DATE: September 9, 2026

SUBJECT: Addendum No. 1 to the Bidding Documents for:

Mehlville School District – Bus Transportation Facility Project

1 FIRST FLOOR PLAN
1/8" = 1'-0"

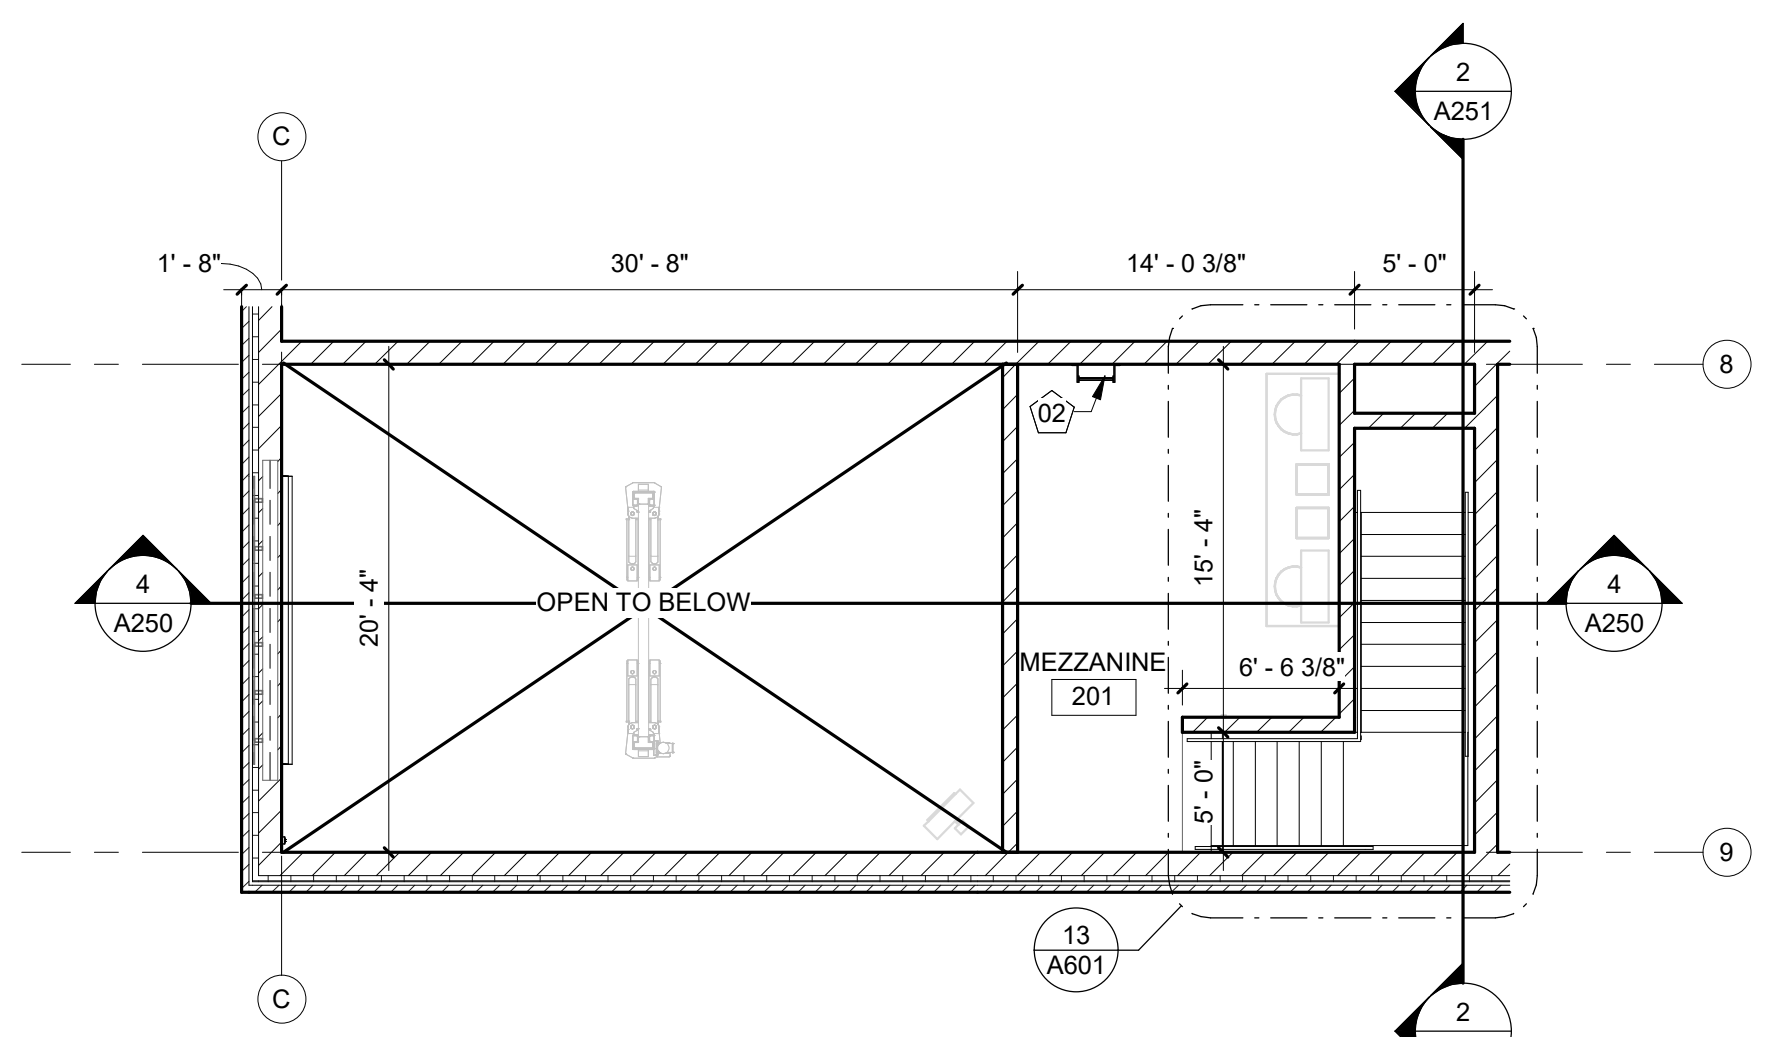
1. Sheet A101 - FLOOR PLANS

- a. **ADD** Floor Plan Keynotes 31 and 33.
- b. **ADD** partition tag at Transportation Manager 109.
- c. **ADD** partition tag at Closet 110.
- d. **ADD** partition tag at Women 115.
- e. **ADD** partition tags at Drivers Room 119.
- f. **ADD** partition tags at Alcove 120.
- g. **ADD** partition tag at Training Office 127.
- h. **ADD** partition tag at Locker Room - Women 132.
- i. **ADD** partition tag at Locker Room - Men 133.
- j. **REVISE** Floor Plan Keynote 32.
- k. **REVISE** partition tag at Closet 110.
- l. **REVISE** partition tag at Corr. 113.
- m. **REVISE** partition tags at Drivers Room 119.
- n. **REVISE** partition tag at Storage 137.
- o. **REVISE** partition tag at Truck Bay 136.

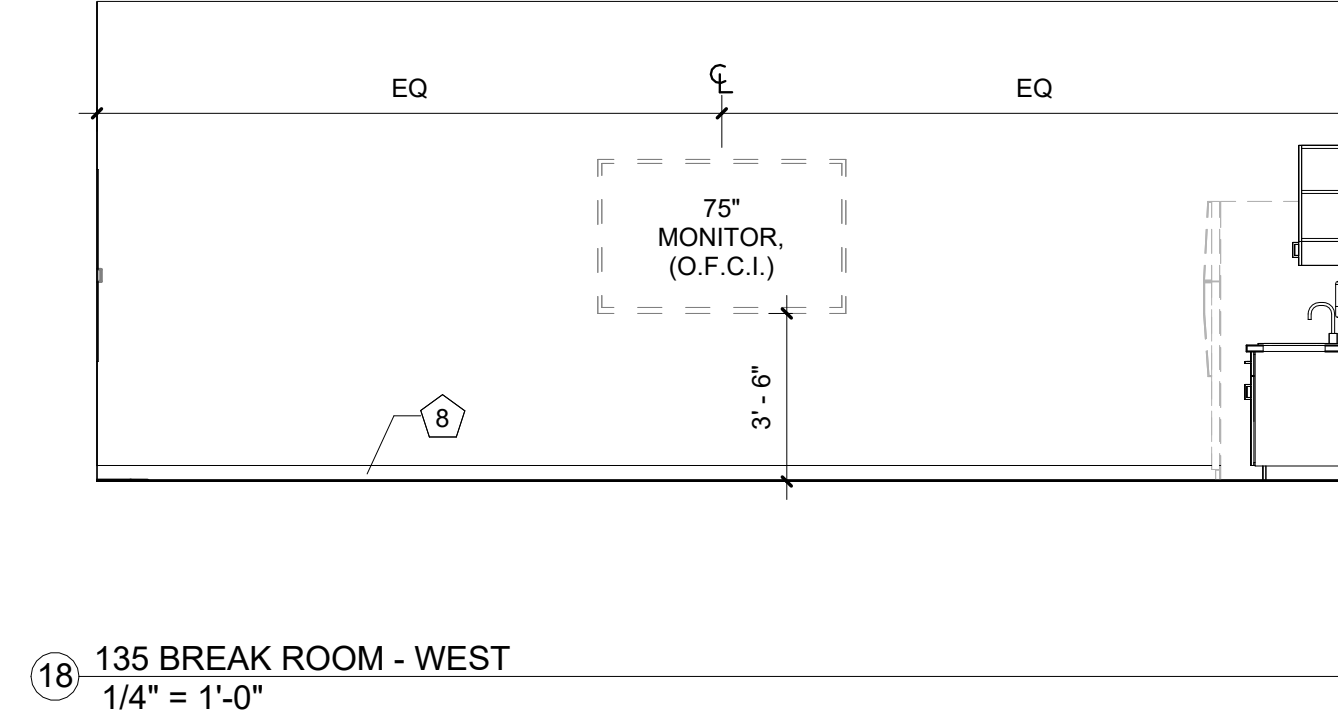
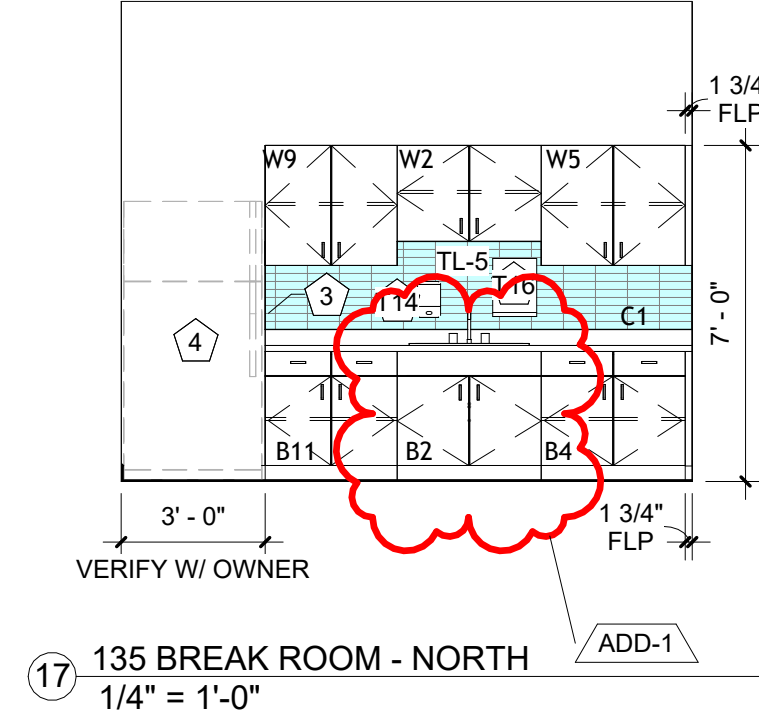
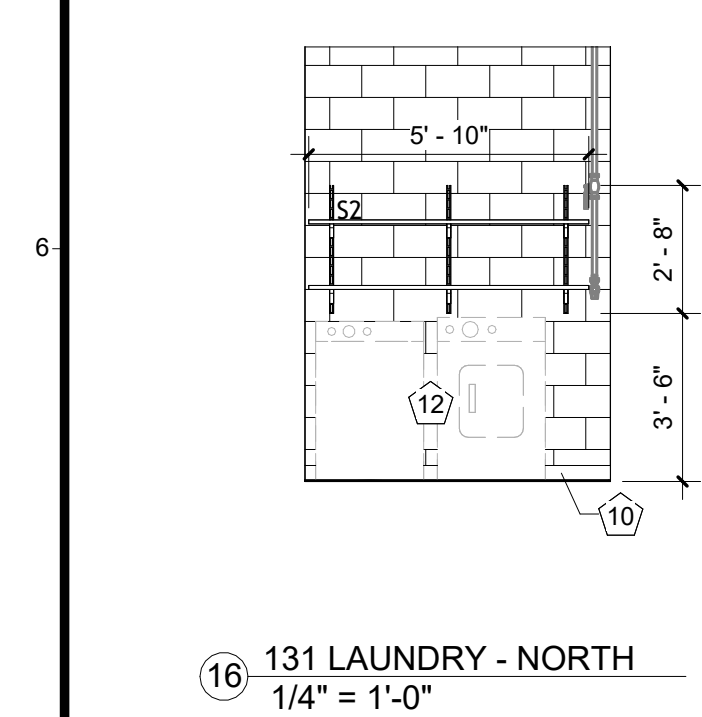
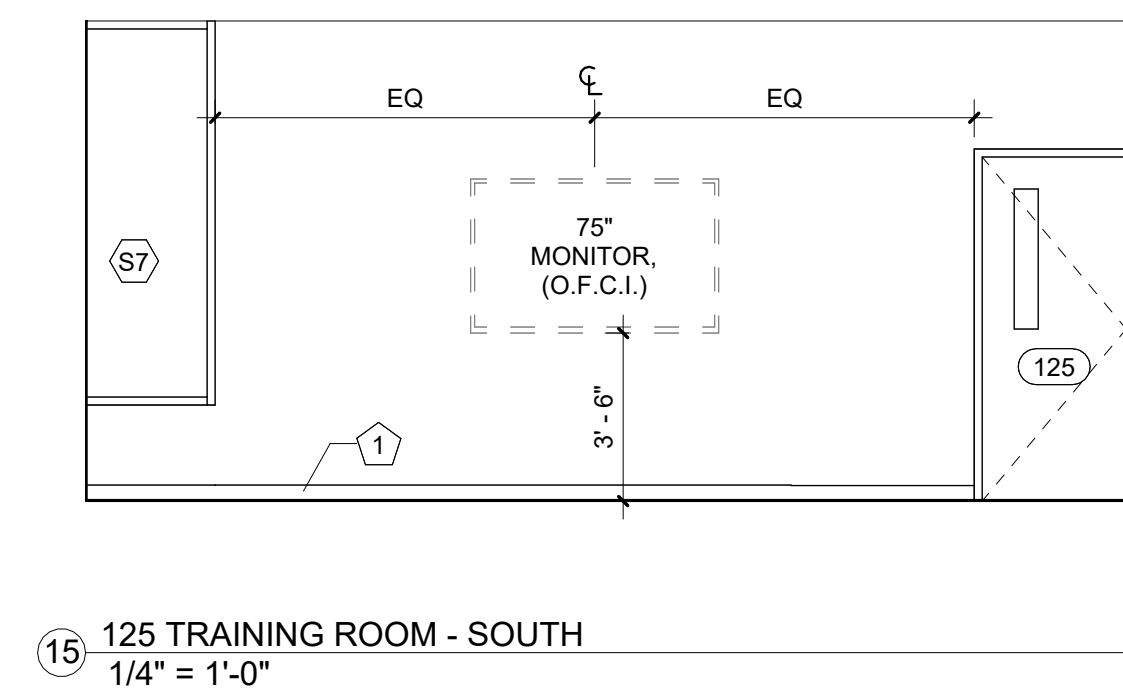
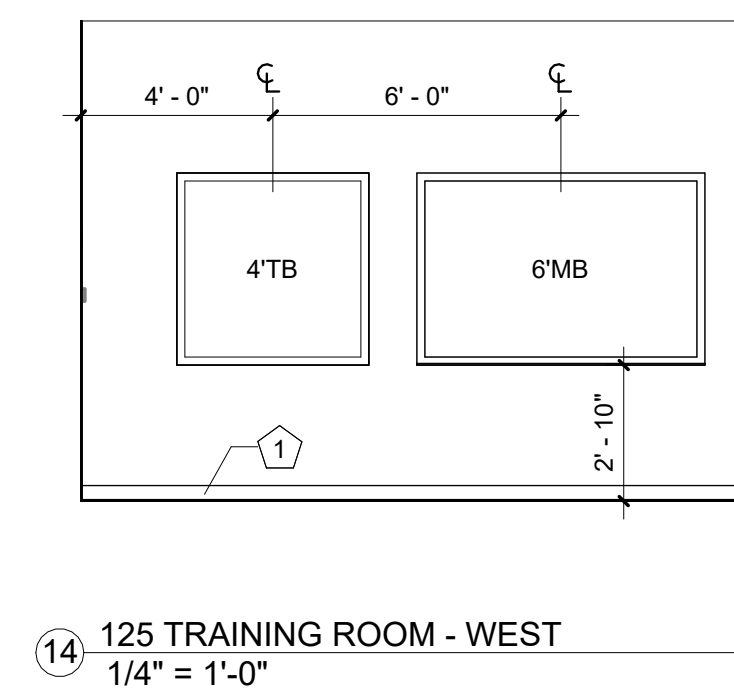
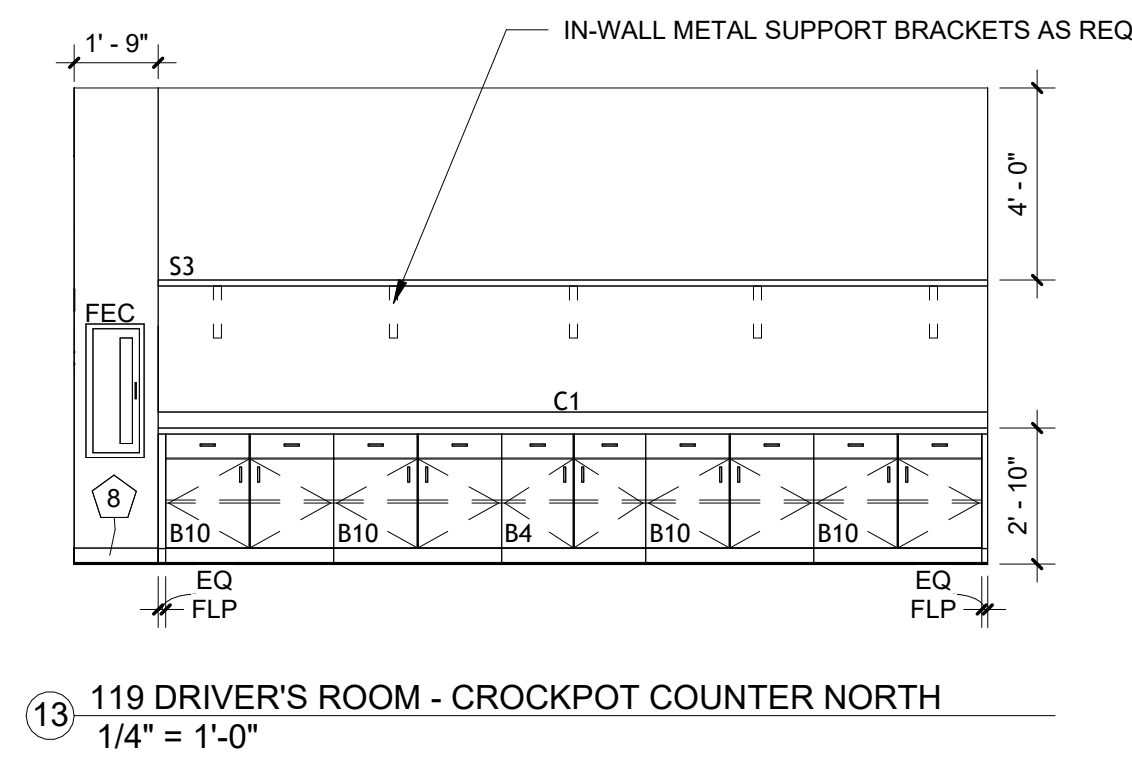
4. Sheet A702 - INTERIOR ELEVATIONS

- a. **REVISE** Casework Schedule information for cabinets B2 and B13.
- b. **REVISE** cabinets B2 cabinets in Views 11 & 17.
- c. **REVISE** cabinet B13 in View 3.
- d. **ADD** text note to View 1.

1 129 DRIVE-THROUGH BAYS - EAST
1/4" = 1'-0"

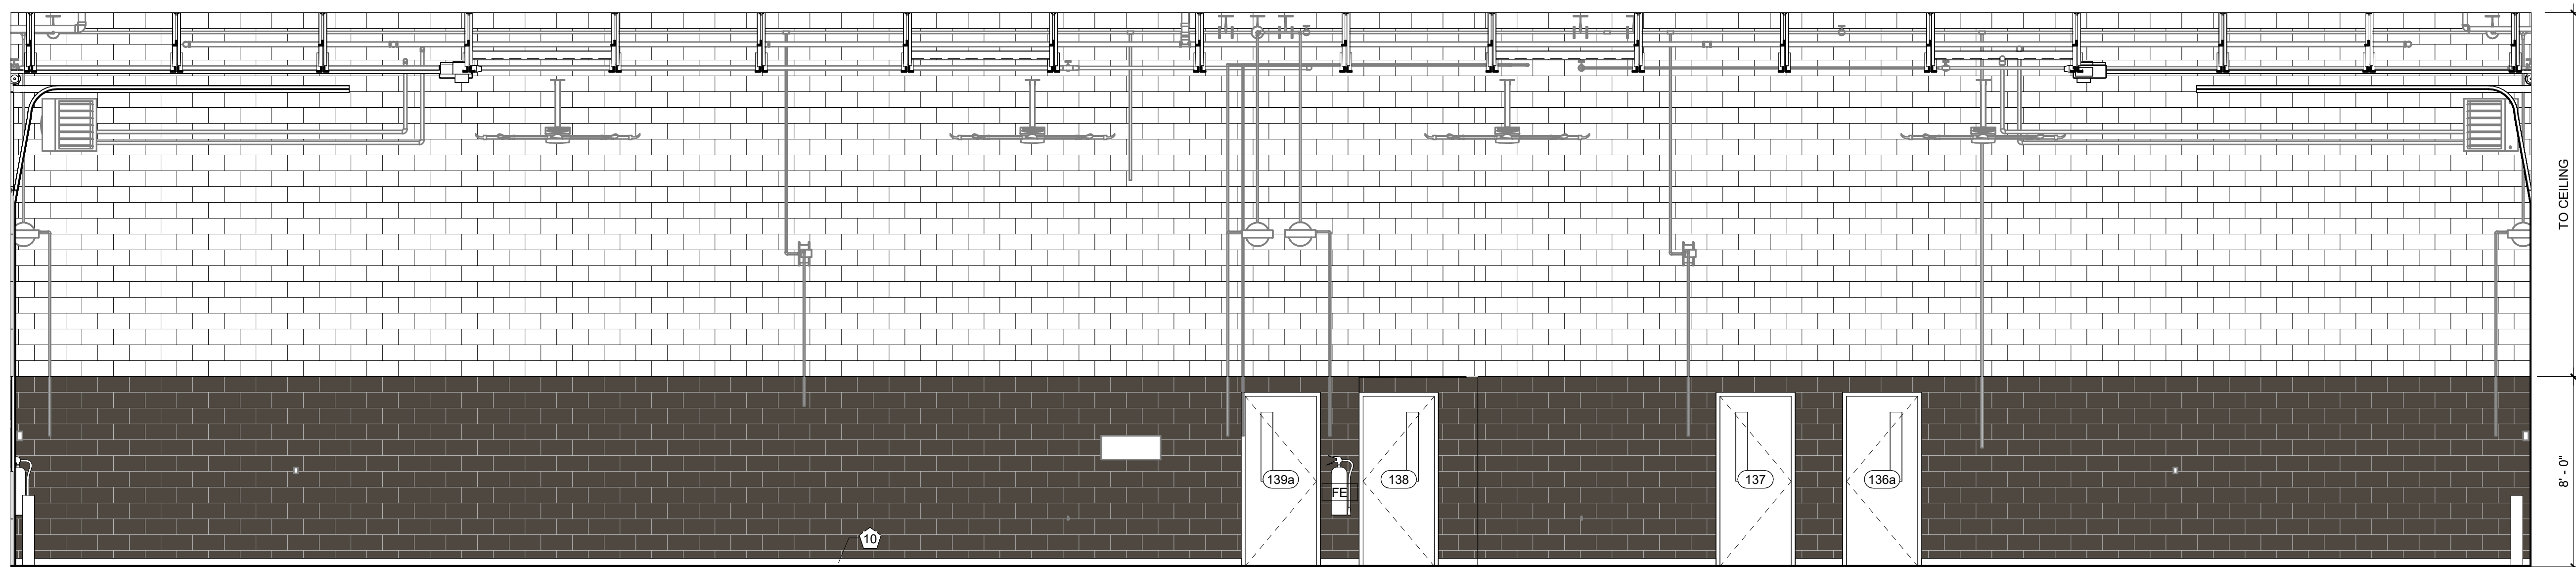
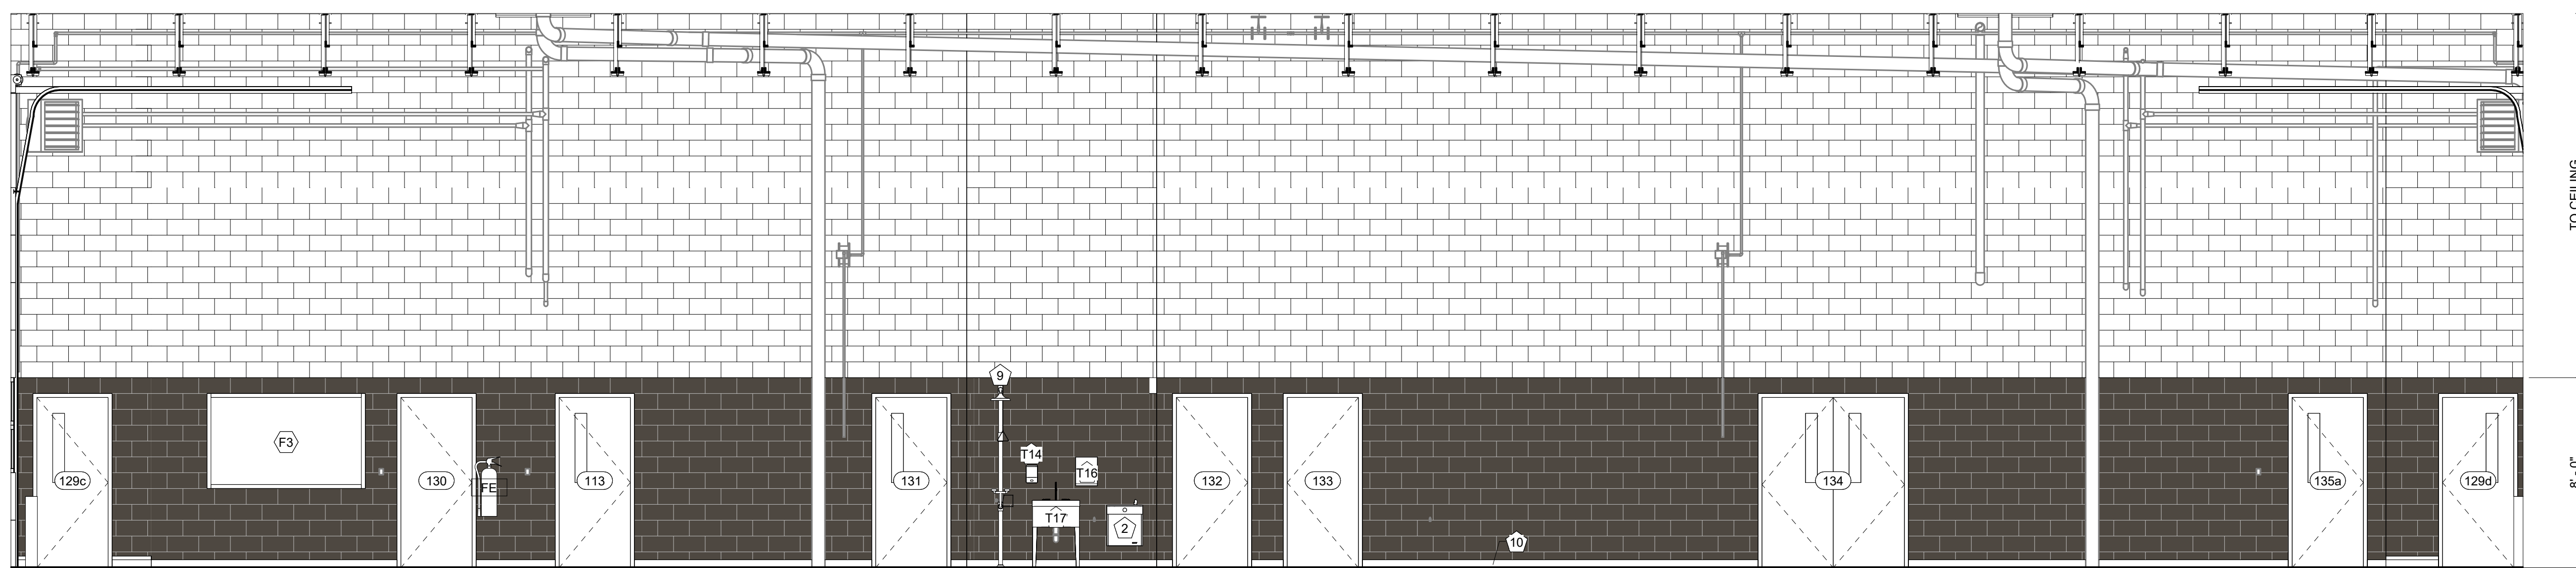
5. Sheet A703 - INTERIOR ELEVATIONS

- a. **REVISE** Casework Schedule information for cabinets B2 and B13.
- b. **REVISE** sheet in its entirety to print correctly.
